Rezoning Transportation Analysis

Petition Number: #2022-218

General Location Identifier: 04118122 and 04118123

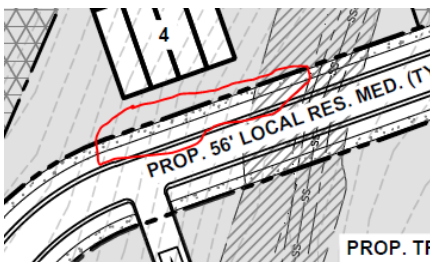
1. ~~Curbline:~~

- a. ~~Milhaven Lane:~~ The future location of curb and gutter is in its current location.

~~NOTE: Additional distance from center line to back of curb may be required in locations where a median is present or around intersections and interchanges.~~

~~Label and dimension the curb and gutter from the centerline for each road on the site plan.~~
